No. 24/71

Service sheet

EXHAUST SYSTEM

B50 MX

Top view of megaphone silencer

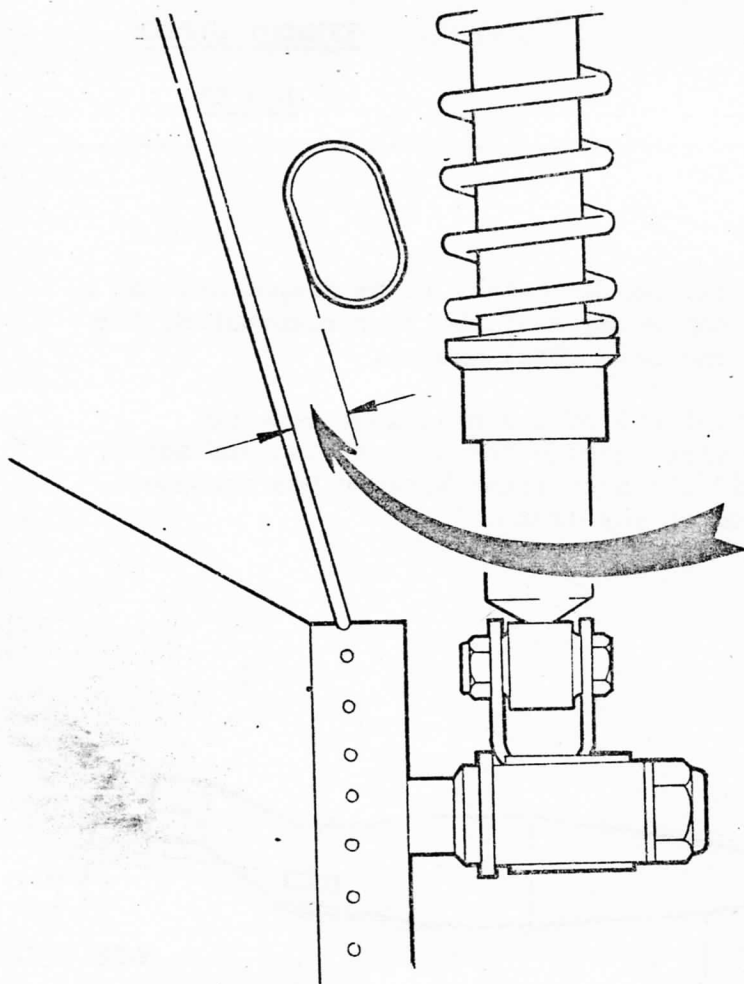
A limited number of the first B50 MX models to be despatched had a condition whereby on full compression of the rear suspension, the megaphone silencer fouled the rear wheel spokes.

To rectify, deform the outlet end of the megaphone cone by compressing in a clamp or vice to make the outlet oval and measure $1\frac{1}{4}$ " across. Secondly, fit a $\frac{1}{4}$ " distance piece between the megaphone bracket and its fixing point on the frame.

Outlet of megaphone silencer
to be parallel with spokes.
